# 1 SUMMARY

**2 APPLICATION DETAILS**

<b>Property Address</b>	6 Island Bay Road, Beach Haven, Auckland
<b>Owner's name(s)</b>	Mr C Walls
<b>Territorial Authority</b>	Auckland Council
<b>Date of Commissioning of Report</b>	5 March 2018
<b>Date of Completion of Report</b>	20 March 2018
<b>Assessor's Name, Address and Contact Details</b>	s 9(2)(a) Dibley Associates Ltd 5 George Street, RD2 Warkworth Auckland.
<b>Site visit(s)</b>	None

### REVISED DRAWINGS –“Island Bay Road Full final set 13-12-17”

TYPICAL SILL SECTION

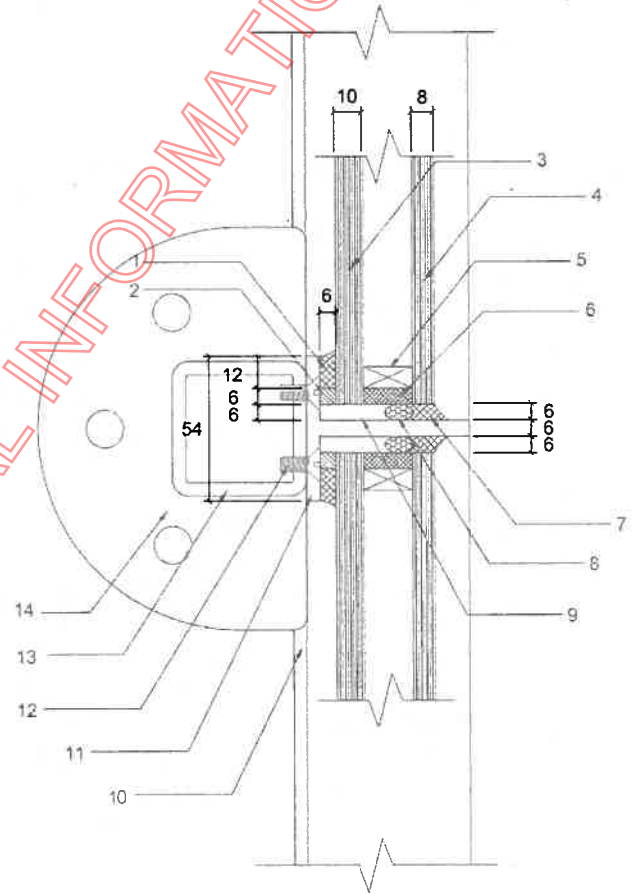
- c) Structural Glazing Tape is to be used on 4 sides of the double glazed units whereas backing rods are noted on the Mullion Section on drawing S18

- iii. references to the structural silicone being applied over backing rod should be amended to over Structural Glazing Tape

Drawings have been updated

Drawings have been updated
